Updated Field Safety Notice

Philips MR systems with MR Elastography (MRE)
Potential for inaccurate (lower) liver stiffness measurements

12/05/2026

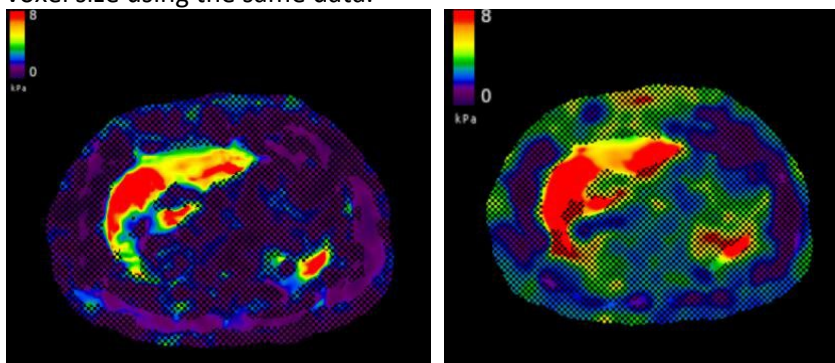
Philips has become aware through the MRE software system developer Resoundant about an issue affecting MRE stiffness measurements when a specific range of image reconstruction parameters is used in combination with Resoundant’s algorithm. Specifically, the reconstruction voxel size settings in the default MRE scan protocol are too small, which can potentially lead to inaccurate liver stiffness measurements (lower values). See Figure 1.
